AGENDA
PLANNING COMMISSION
116 WEST NEEDLES
BIXBY, OKLAHOMA
May 20, 2013 **6:00 PM**

8. **BSP 2013-02 – Panda Express – Bannister Engineering, LLC (PUD 67).** Discussion and possible action to approve a PUD Detailed Site Plan and building plans for “Panda Express,” a Use Unit 12 restaurant development for part of the NW/4 SW/4 of Section 25, T18N, R13E.

9. **BSP 2013-03 – Grand Bank – Sisemore, Weisz & Associates, Inc. (PUD 65).** Discussion and possible action to approve a PUD Detailed Site Plan and building plans for “Grand Bank,” a Use Unit 11 bank and retail development for Lot 5, Block 1, *101 Memorial Square.*

To: Bixby Planning Commission
From: Erik Enyart, AICP, City Planner
Date: Friday, April 26, 2013
RE: Report and Recommendations for:
*PUD 77 – “Byrnes Mini-Storages” – JR Donelson, Inc., and
BZ-365 – William W. Wilson for Helene V. Byrnes Foundation*

EXHIBIT A
PRELIMINARY
PLAT

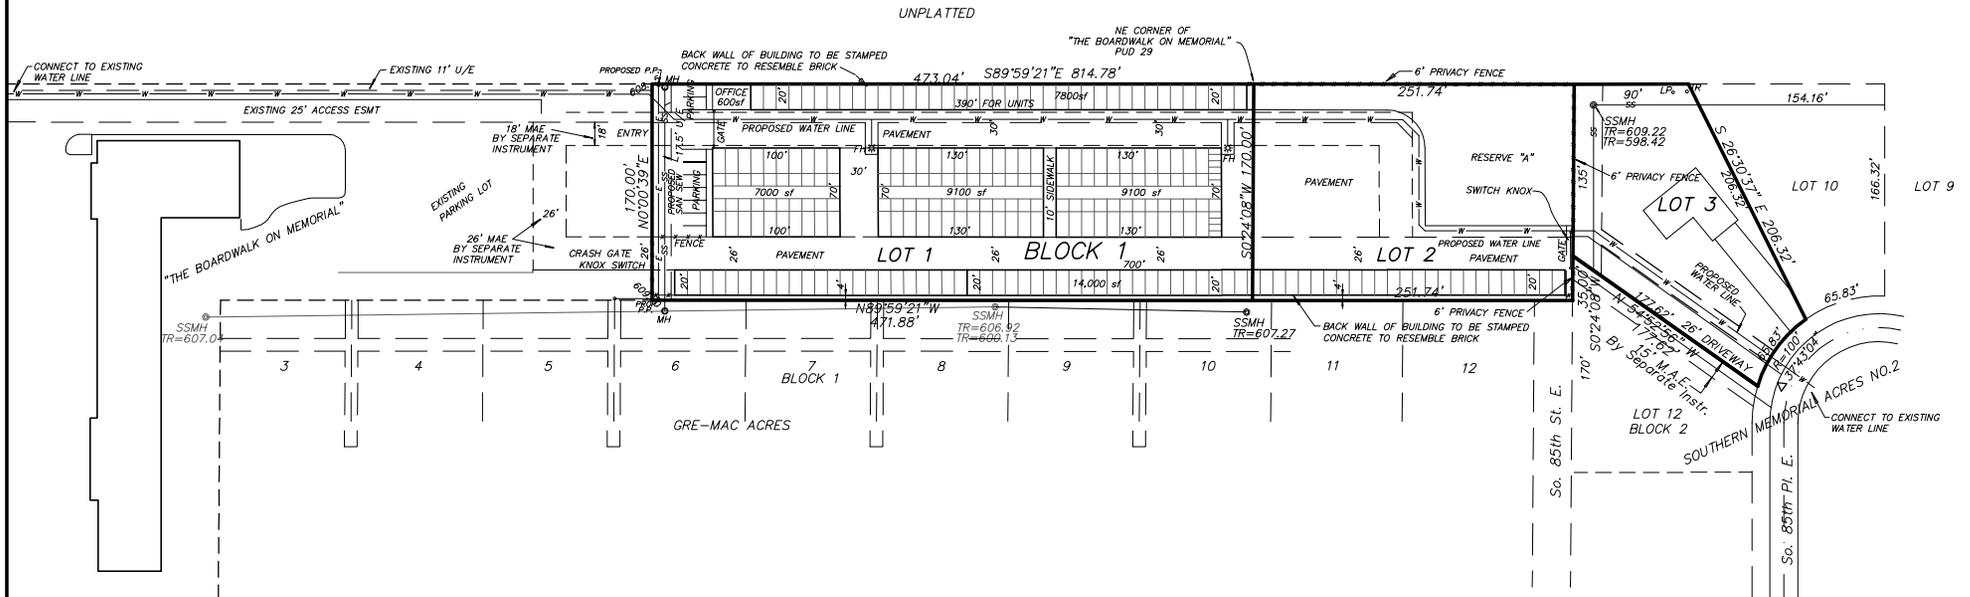
6. *The PUD needs to specify that the existing U/Es will be vacated, and the Applicant will request a Modification/Waiver of the 17.5' Perimeter U/E requirement when platting, and specify to propose, in lieu thereof, a U/E between the northernmost buildings to allow the waterline loop, and future utilities as may be necessary.*

7. *"Roadway Easement" granted from Gail & John Horne to The Helene V. Byrnes Foundation, Document # 2013018388, recorded 02/22/2013, grants easement over "The Northwesterly 15 feet" of Lot 12. Based on its representation on the provided exhibits, it is assumed to have meant the "Northeasterly 15 feet." Otherwise, the described area may be a pie-shaped piece extending southeasterly from the northwest corner of said Lot 12, which may not allow for the emergency-only 26'-wide drive as shown on the plans. Please clarify and/or correct easement if/as needed.*

SECTION 1
 LOCATION MAP
 SCALE: 1" = 2000'
 SUBDIVISION CONTAINS:
 AREA = 3.682 ACRES 160,400 sf
 NO. LOTS 3 BLOCKS 1
 April 6, 2013
 C: WILSON\EXHIBIT-B.DWG

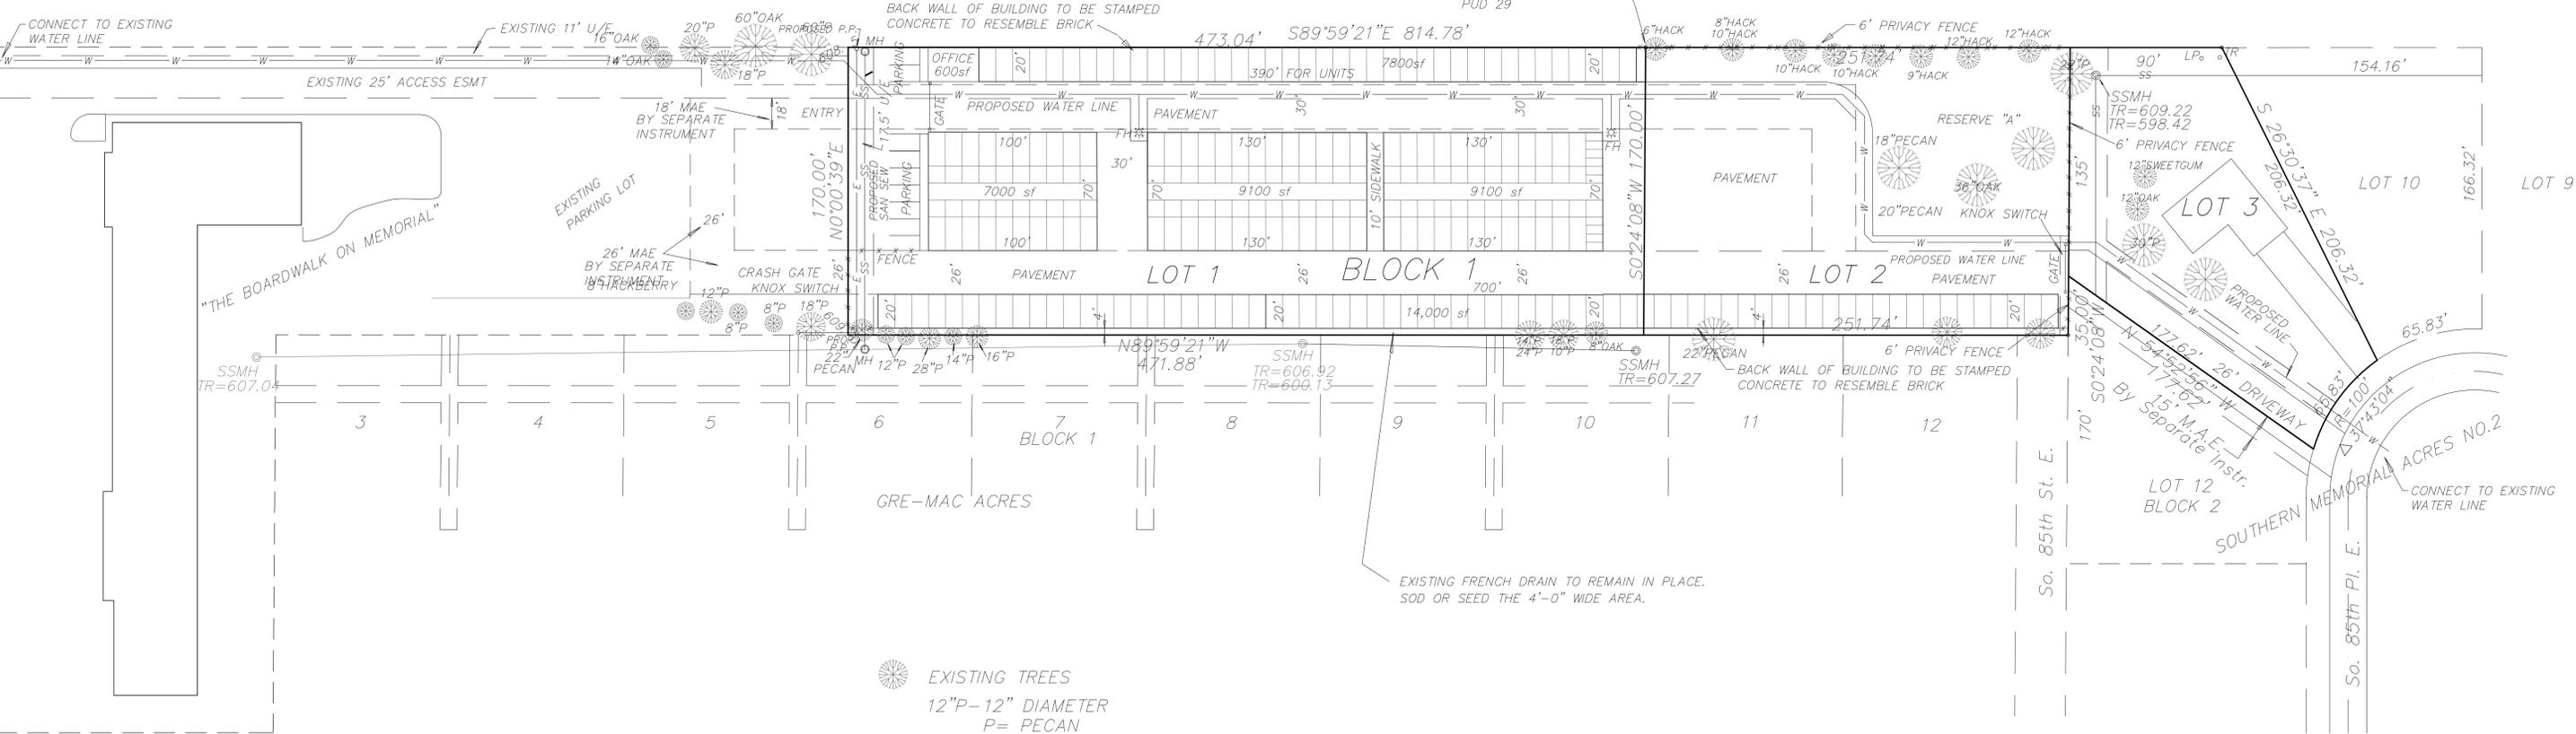
19. Exhibit C: Please restore PUD name or add PUD #.
20. Exhibit G: Please confirm all existing trees of a certain minimum caliper (must be defined) are represented within X' (4' minimum) north and south of the south line of DA A and represent any currently missing. Aerial and satellite imagery indicate several other trees than are represented on the exhibit, but their sizes are not known.

PATIO & TRASH ENCLOSURE DETAILS

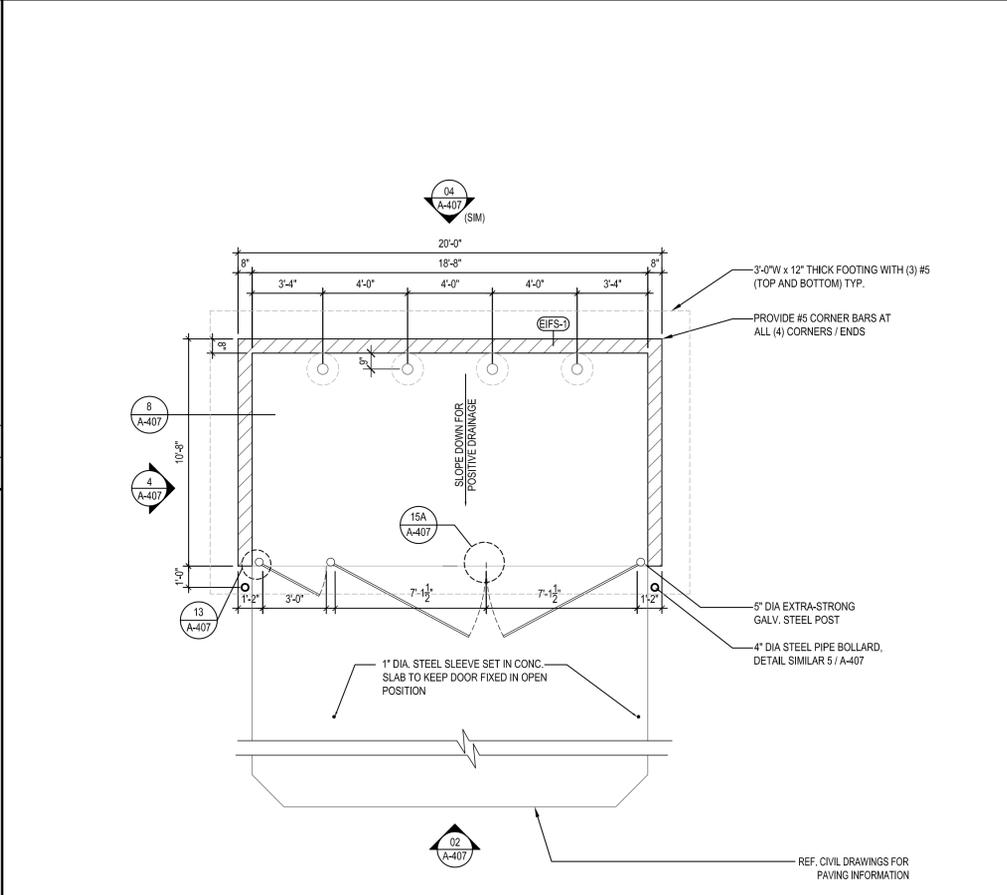
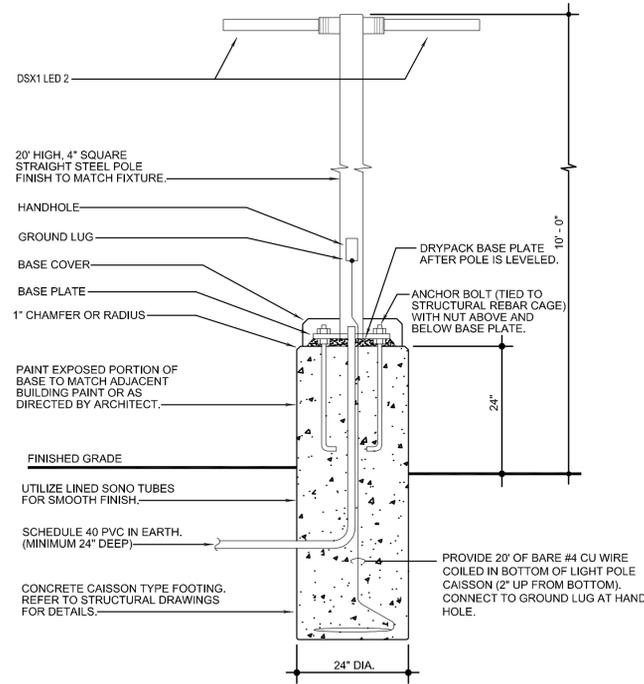
The trash dumpster area will be enclosed within a screening wall enclosure, to be composed EIFS with a 2.5'-tall "Mesa LedgeStone" base and "galvanized steel" gates. The trash enclosure details are provided on "Patio & Trash Enclosure Details" drawing A-407, and appear typical for this type of application.

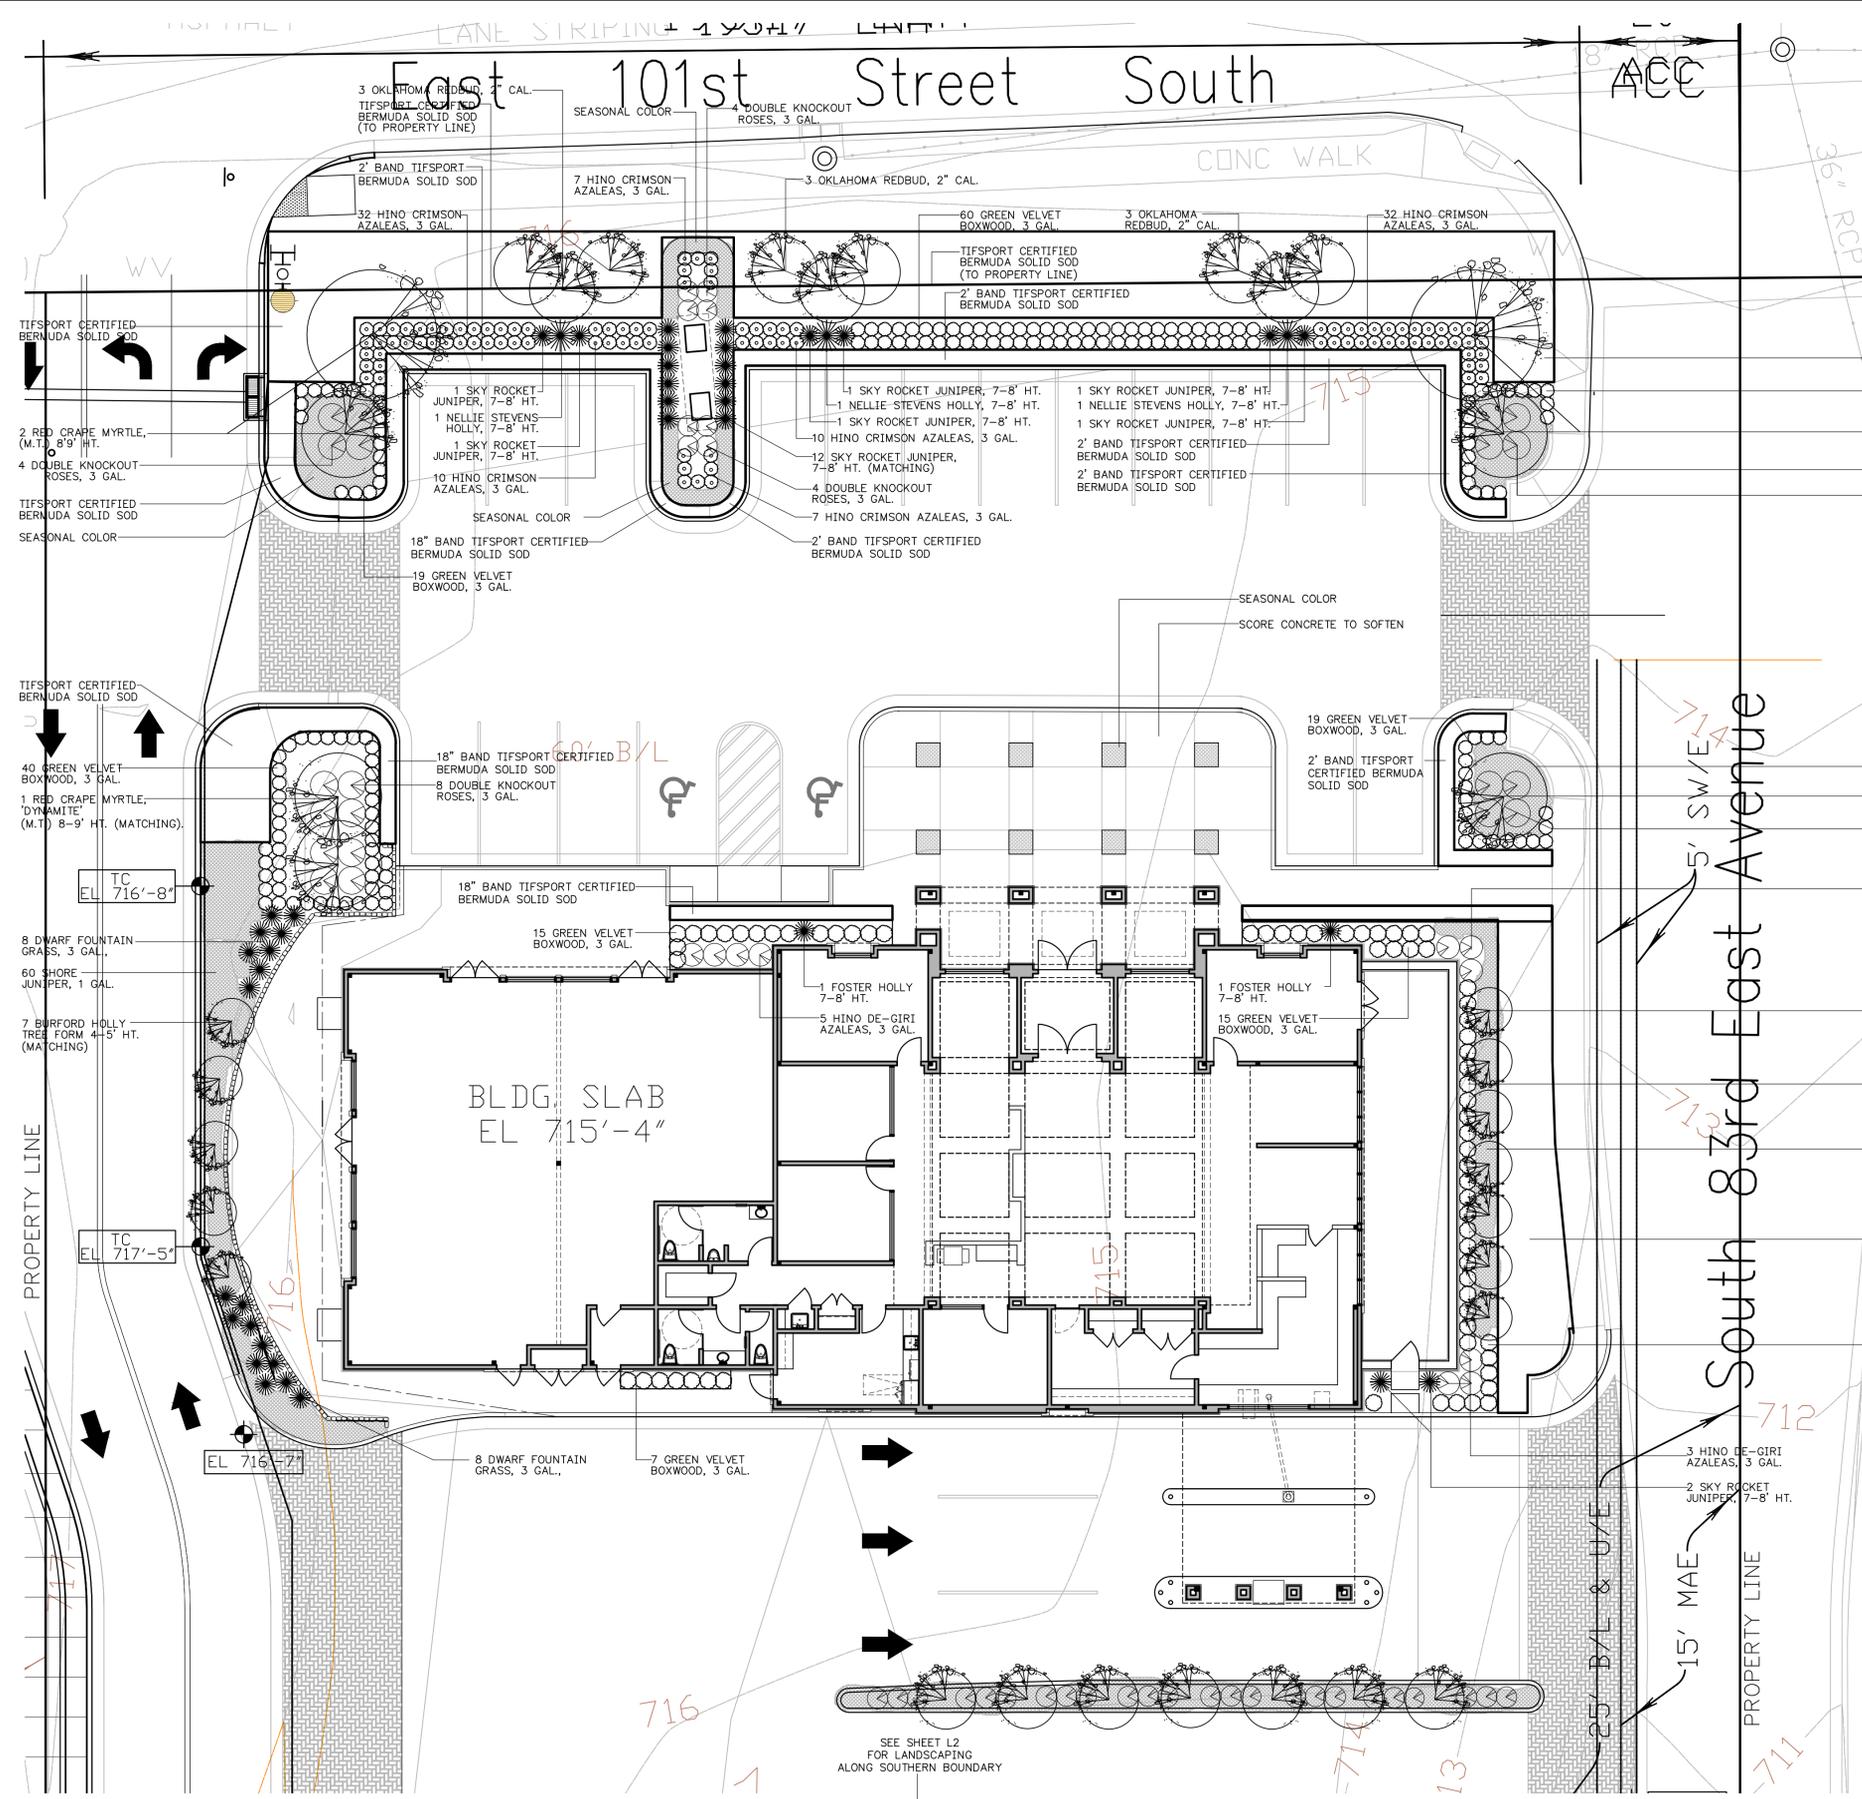
Parking Standards. The "Detail Site Plan" drawing DSP-1 indicates a total of 31 parking spaces. Zoning Code Section 11-10-2.H provides a "minimum plus 15%" maximum parking number cap, to prevent excessive parking that results in pressure to reduce greenspaces on the development site.

7. Tree to Parking Space Ratio Standard (Section 11-12-3.C.2): Standard is one (1) tree per 10 parking spaces. The "Detail Site Plan" drawing DSP-1 indicates a total of 31 parking spaces. 31 / 10 = 3.1 = 4 (1/10 of a tree is not possible, and minimum numbers of required trees are not rounded-down) trees required by this standard. Excluding trees elsewhere accounted for, 5 Burford Holly trees proposed along the west side of the property. **This standard is met.**

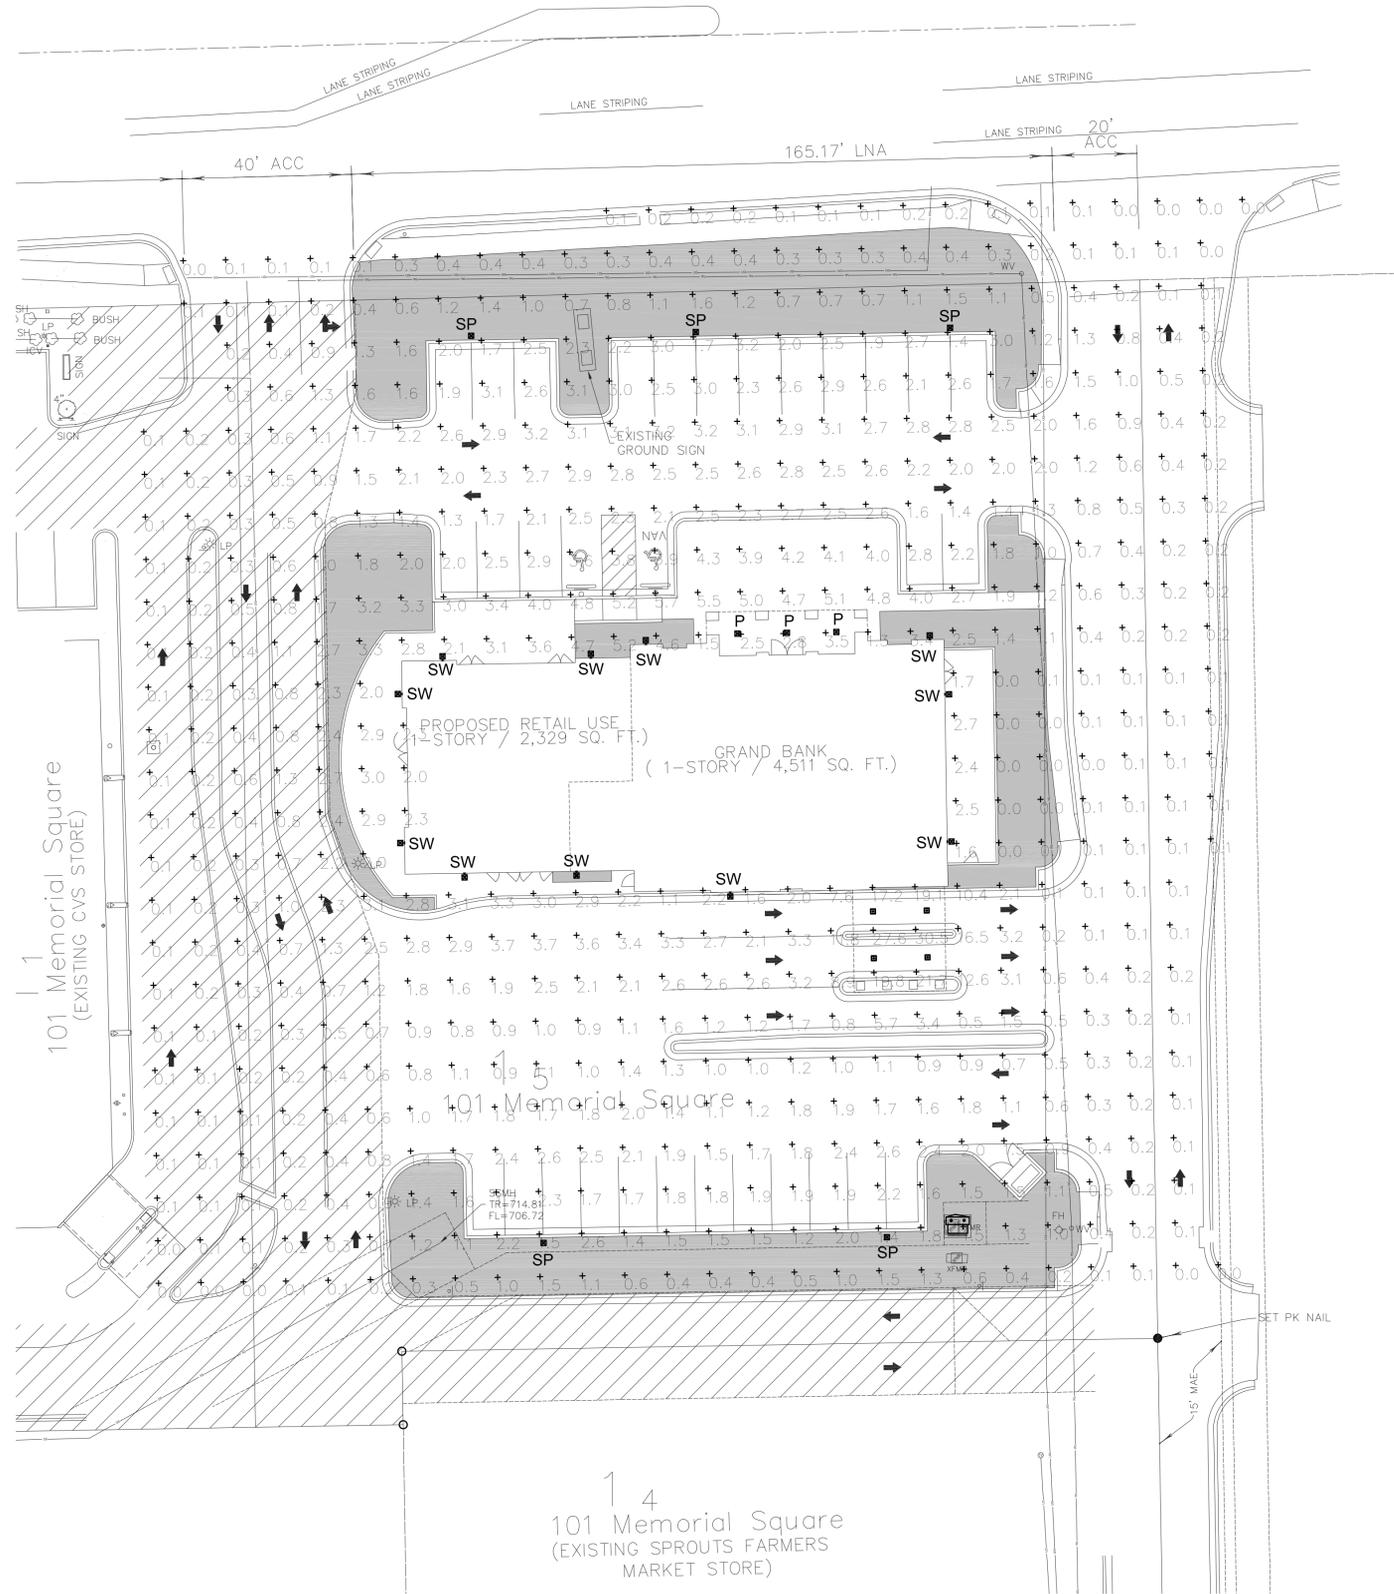
9. Irrigation Standards (Section 11-12-3.D.2): A note on "Landscape Plan (Northern Portion)" drawing L1 states "All landscape area required by the Landscape Ordinance shall be irrigated by an underground sprinkler system." Zoning Code Section 11-12-4.A.7 requires the submission of plans for irrigation. An irrigation plan was not submitted. **This standard is not met.**
